Re: Giroux & Firehouse Plaza Amendments - DRB Follow-up Materials

Re: Commerce Park Subdivision, Giroux Subdivision, Automotion Site Plan Amendment, Firehouse Plaza Site Plan Amendment - Follow-up to DRB Hearing

TO: HINESBURG DEVELOPMENT REVIEW BOARD
FROM: BRIAN J. BERTSCH, P.E.
SUBJECT: AUTOMOTION & FIREHOUSE PLAZA
SITE PLAN AMENDMENT APPLICATIONS
DATE: FEBRUARY 6, 2014
CC: STEPHANIE HAINLEY

Site Plan Revision

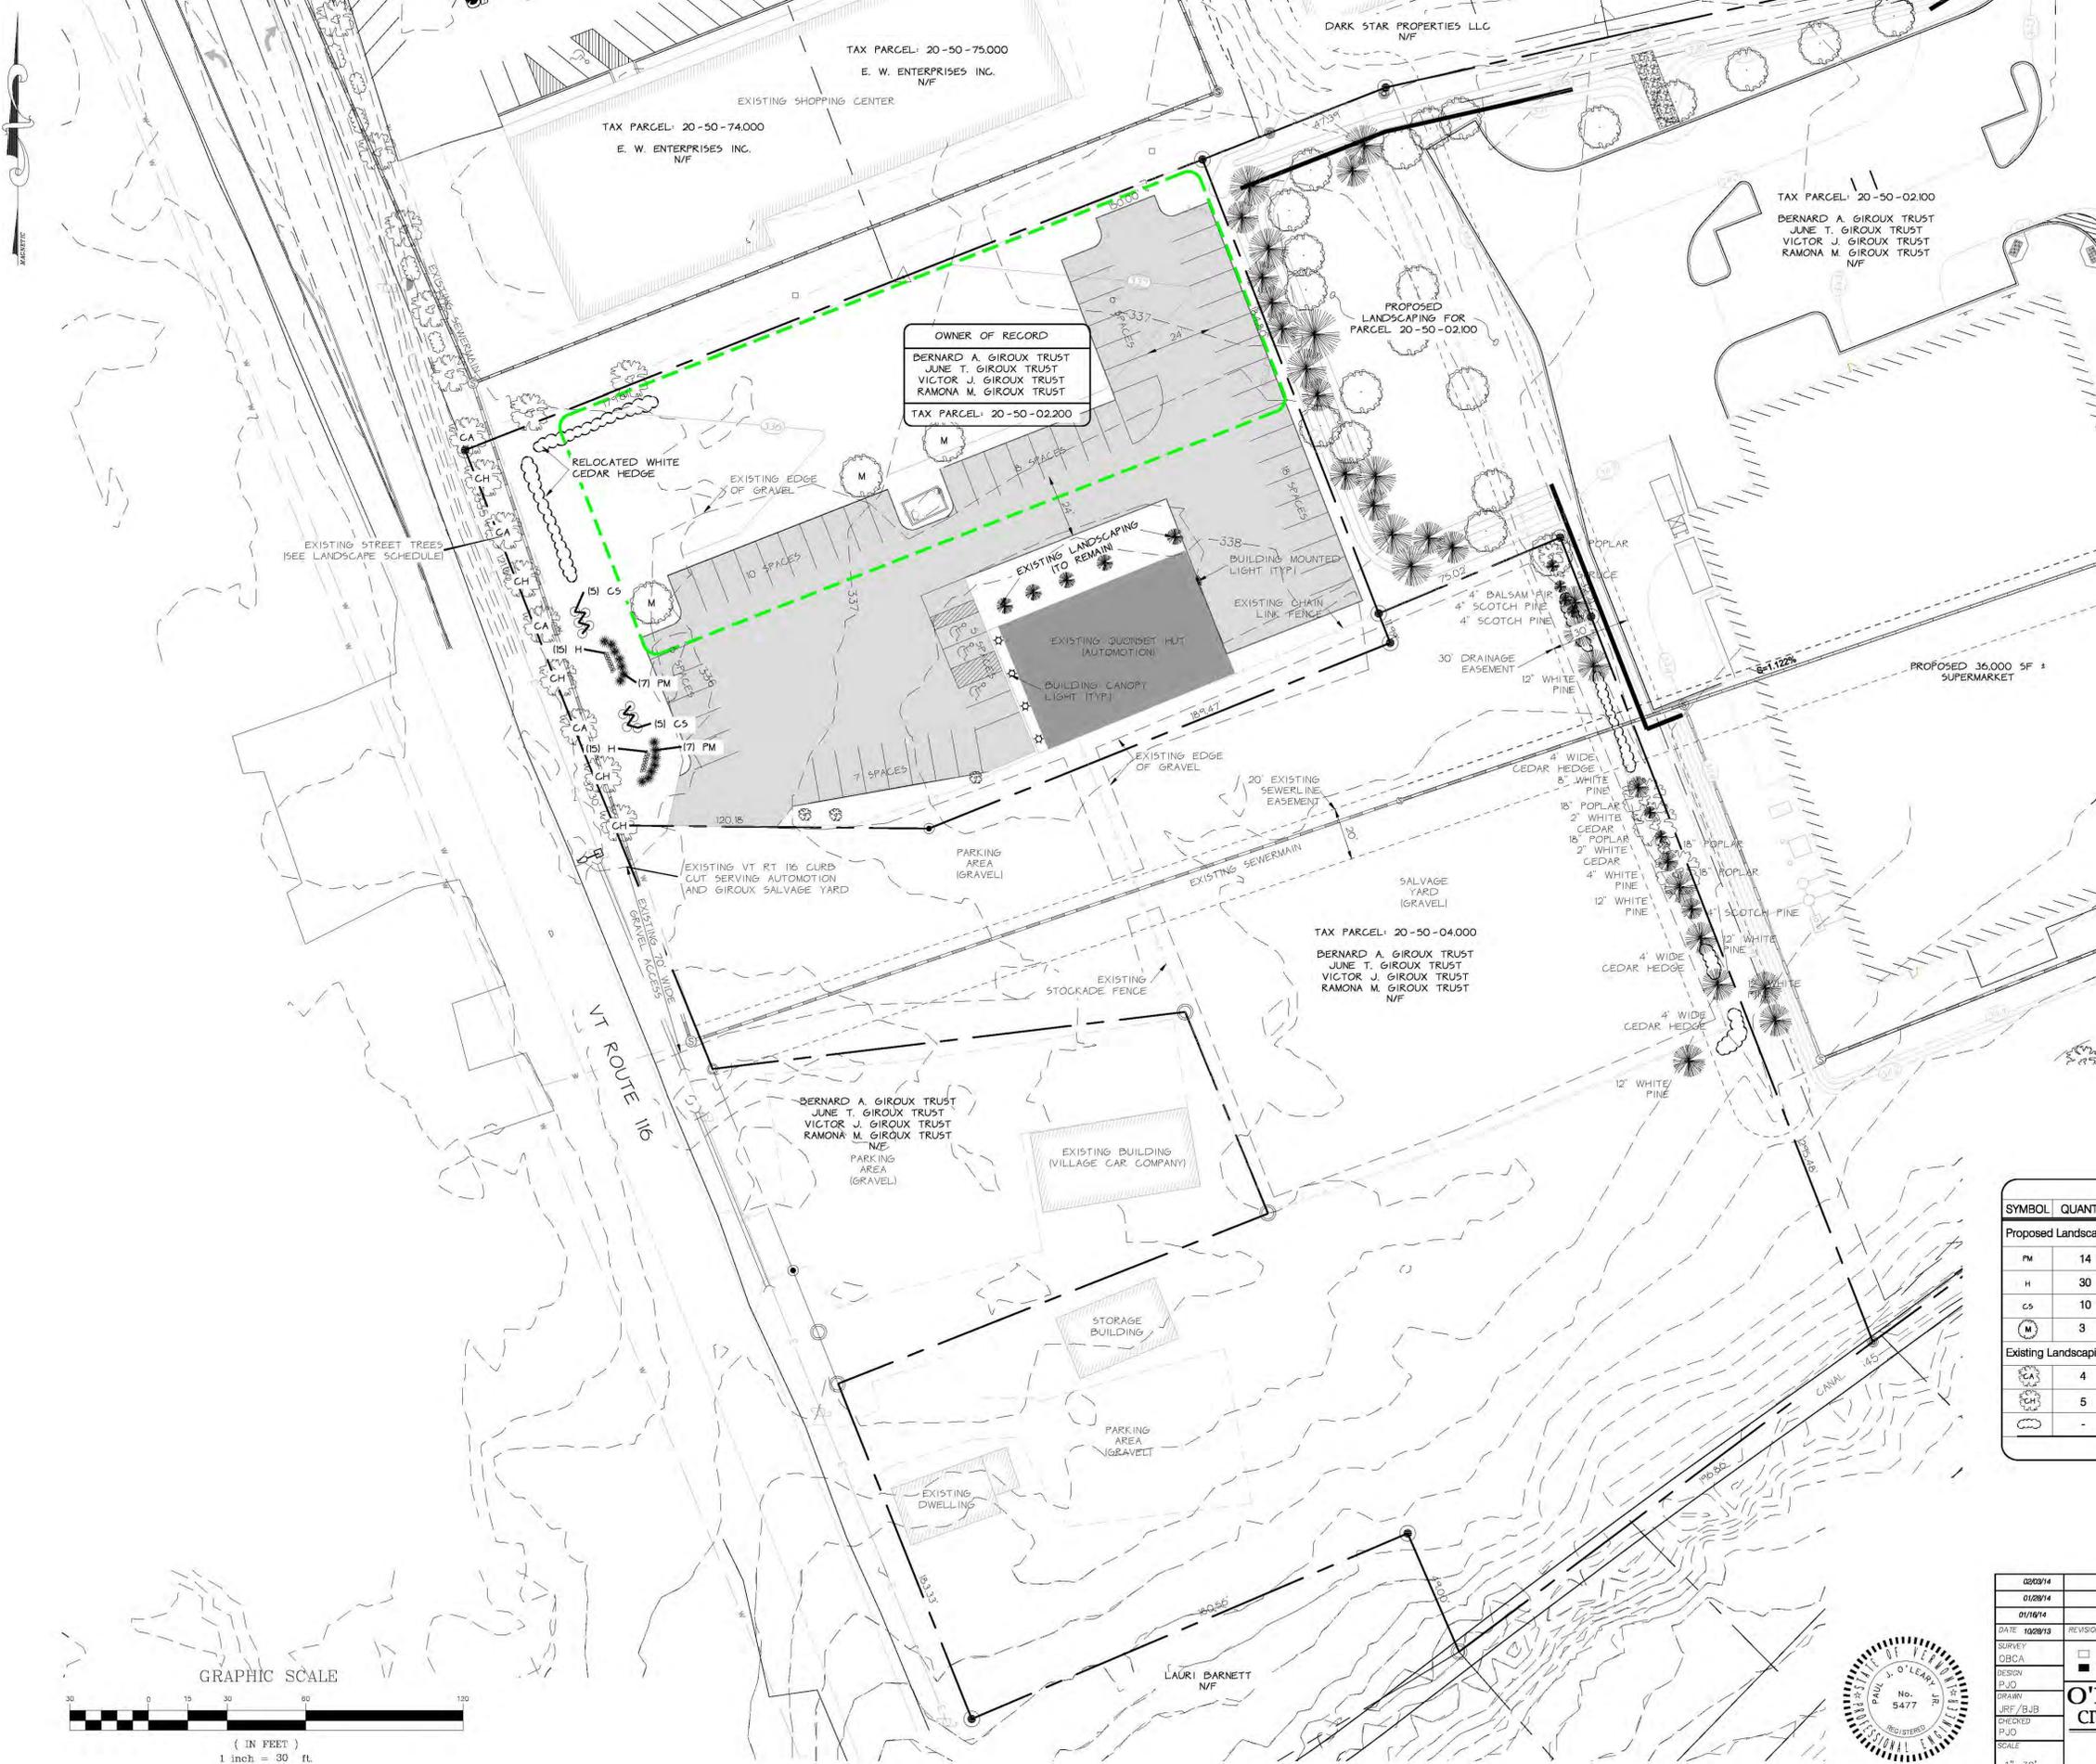
The current proposal to expand the Automotion parking area will create less than 5,000 sq. ft. of new impervious area. We have graded the new parking spaces to drain west, instead east, to further reduce runoff to the Darkstar swale. A summary of the pre vs post flow patterns has been depicted below:

An added benefit of draining the rear portion of the Automotion property west, instead of east, is that the length of overland flow has increased. Under current conditions runoff from the gravel parking area behind Automotion flows via sheet flow for a length of approximately 90 feet into the Darkstar swale. Under the proposed conditions runoff from the new gravel parking area, and the minimal amount of runoff which will come down the 3:1 slope of the farmers market, will sheet flow for approximately 100 feet before it concentrates and flows an additional 140 feet over grass before entering the VT RT116 swale.

The flow path measured from the rear parking area of the Automotion property to Patrick Brook is approximately 695' feet via the Darkstar swale versus 1,050 feet via the VT 116 swale.

In addition, the current proposal results in slightly less impervious area than what the site was originally approved for. When compared to the approved plan and the existing conditions, the proposed plan provides a greater opportunity for natural stormwater treatment than the site currently receives.
